IN THE MATTER OF ROCKY MOUNTAIN
POWER'S FILING FOR
ACKNOWLEDGEMENT OF ITS 2021
INTEGRATED RESOURCE PLAN

CASE NO. PAC-E-21-19

JOINT COMMENTS OF SIERRA
CLUB AND IDAHO
CONSERVATION LEAGUE

Figure 2. Historic Henry Hub Prices and PacifiCorp's IRP Natural Gas Price Forecast

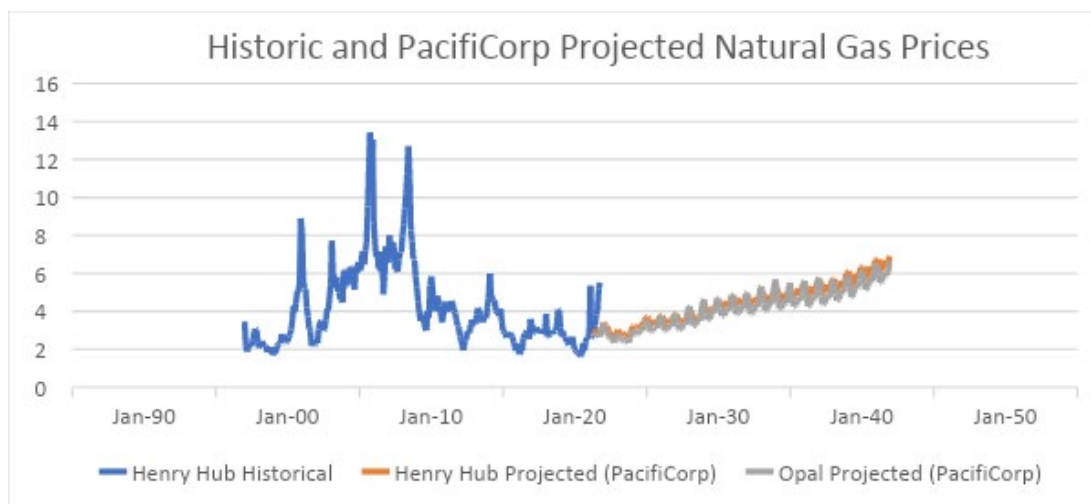
PacifiCorp’s IRP forecast expects these low prices to continue for the entire planning horizon. As shown in Figure 1, PacifiCorp’s forecast for Henry Hub natural gas prices begins in April 2021 at just under \$3/MMBtu, slowly rise to \$4 in 2029, \$5 in 2034, and ultimately top off at just under \$7/MMBtu by 2041.⁸⁷

However, gas prices have nearly doubled in the past year alone.⁸⁸ Prices rose sharply in February 2021 after the Texas winter storm, dropped quickly, but then immediately started a persistent climb in March 2021 until today. Because PacifiCorp had to lock in its gas price forecast as an input for its IRP in early 2021, we can track the Company’s forecast to actual gas

Figure 3. Henry Hub Prices Since January 2020, and PacifiCorp's Gas Price Forecast

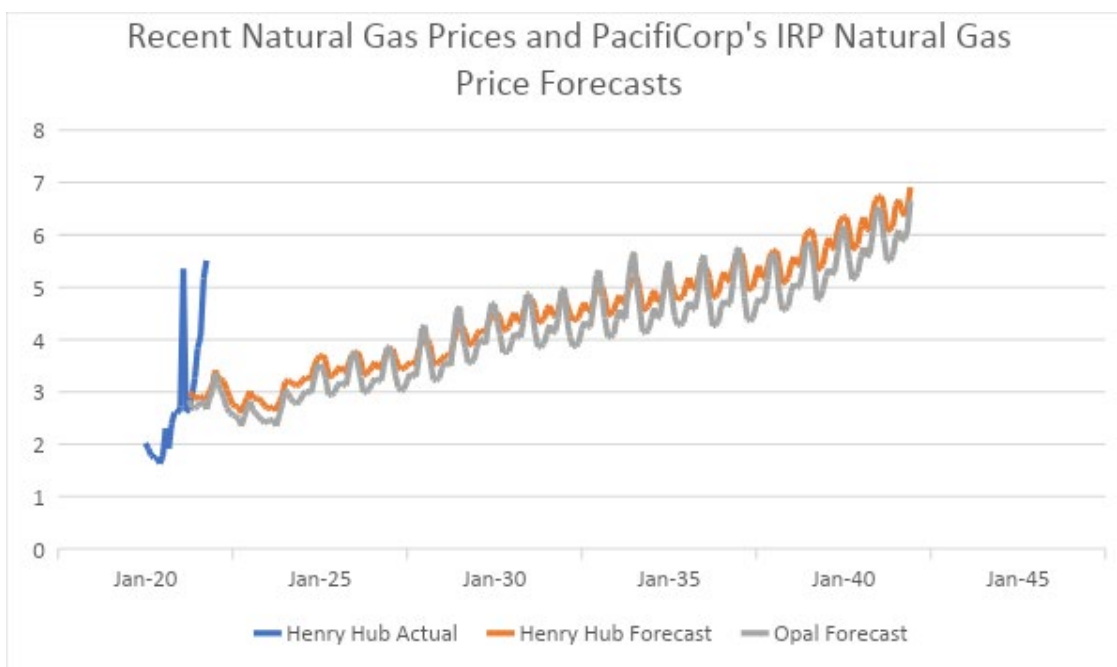
prices. Since April 2021, actual gas prices have significantly increased relative to the Company’s forecast. In October 2021, the Henry Hub price for gas was \$5.51/MMBtu, nearly double the Company’s forecast of \$2.84/MMBtu.

Despite this dramatic increase in gas prices in 2021 PacifiCorp is optimistic that prices will revert to their historic low. According to the IRP, as of June 30, 2021, gas futures show a high price of \$3.17/MMBtu, which is a “signal-to-drill” and will incent drillers to chase production efficiency and continue to drive down prices.⁸⁹ PacifiCorp continued that “[t]he North American natural gas supply curve continues to flatten as production efficiencies expose an ever-increasing resilient, flexible, and low-cost resource base.”⁹⁰

Figure 4. U.S. Natural Gas Production

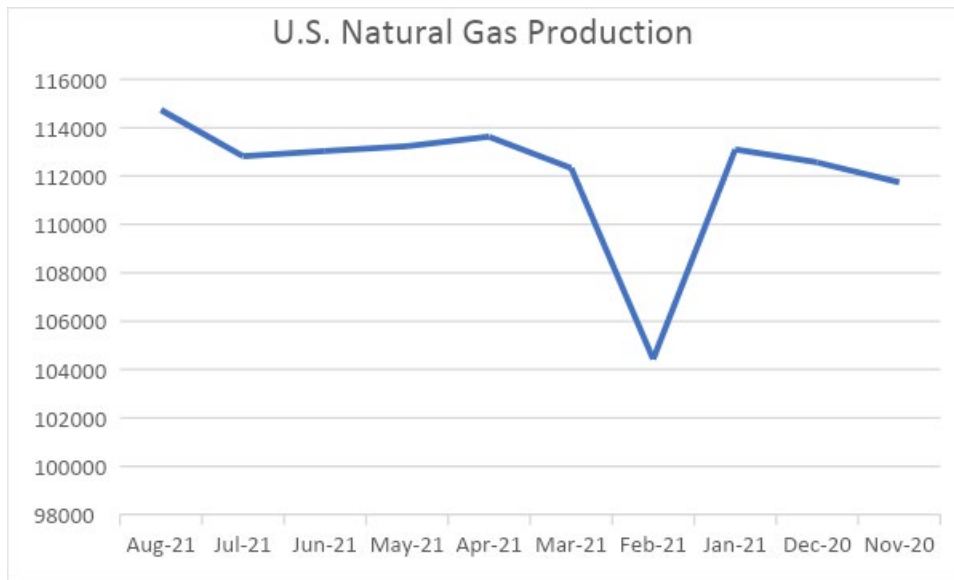
chase production as PacifiCorp predicted, domestic fracked gas production has remained relatively flat since November 2020.⁹¹ While gas prices remain high, and demand responds to seasonal needs, overall U.S. gas supply has remained flat through March 2022.⁹²

Figure 5. Figure 7.5 from PacifiCorp 2021 IRP Volume I Compared to NREL Cost Assumptions

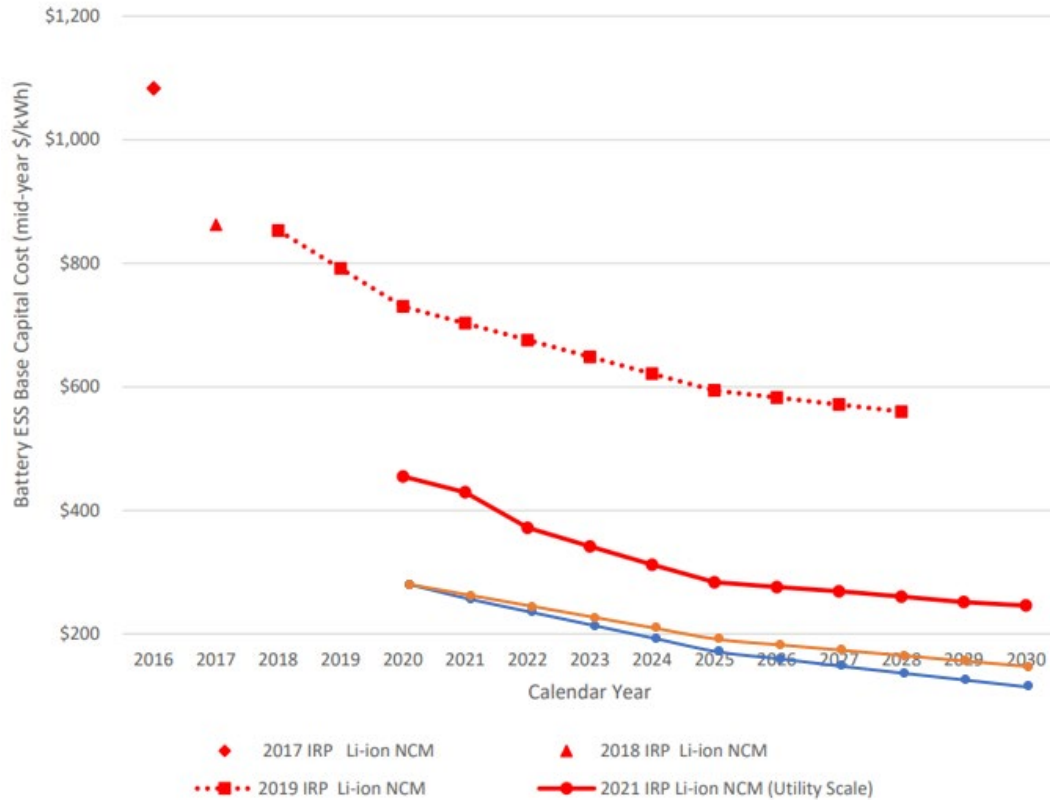
PacifiCorp's assessment is fairly comparable with the most recent (2021) Annual Technology Baseline ("ATB") report by the National Renewable Energy Lab ("NREL") with the exception of battery storage cost estimates, which differ significantly. For example, PacifiCorp assumed that a 4-hour Li-Ion battery, that is available in 2021 and has a commercial operation year of 2023, has a capital cost of \$1,820/kW, while NREL's ATB predicts \$1,281-1,351/kW for 2021 installations and \$1,070-1,275/kW for 2023 installations.¹⁰⁹ Similarly, PacifiCorp assumed a capital cost of \$4,622/kW for an 8-hour battery, while NREL's ATB projects the cost to be \$2,318-2,444/kW in 2021 and \$1,937-2,307/kW in 2023. The 2021 IRP's Figure 7.5 (provided in Volume I) shows the forecast of storage costs that informed the Company's modeling. The below figure provides the IRP's cost curves with the NREL's moderate and advanced cost assumptions, identified by the orange and blue lines respectively.

PacifiCorp’s higher cost assumption combined with other flawed assumptions and modeling choices, such as the capacity contribution of hybrid solar plus storage assets (as discussed above in Section II(A)) and the low gas prices (as discussed above in Section V), caused underinvestment in clean energy and storage technologies in the Company’s optimized portfolios.
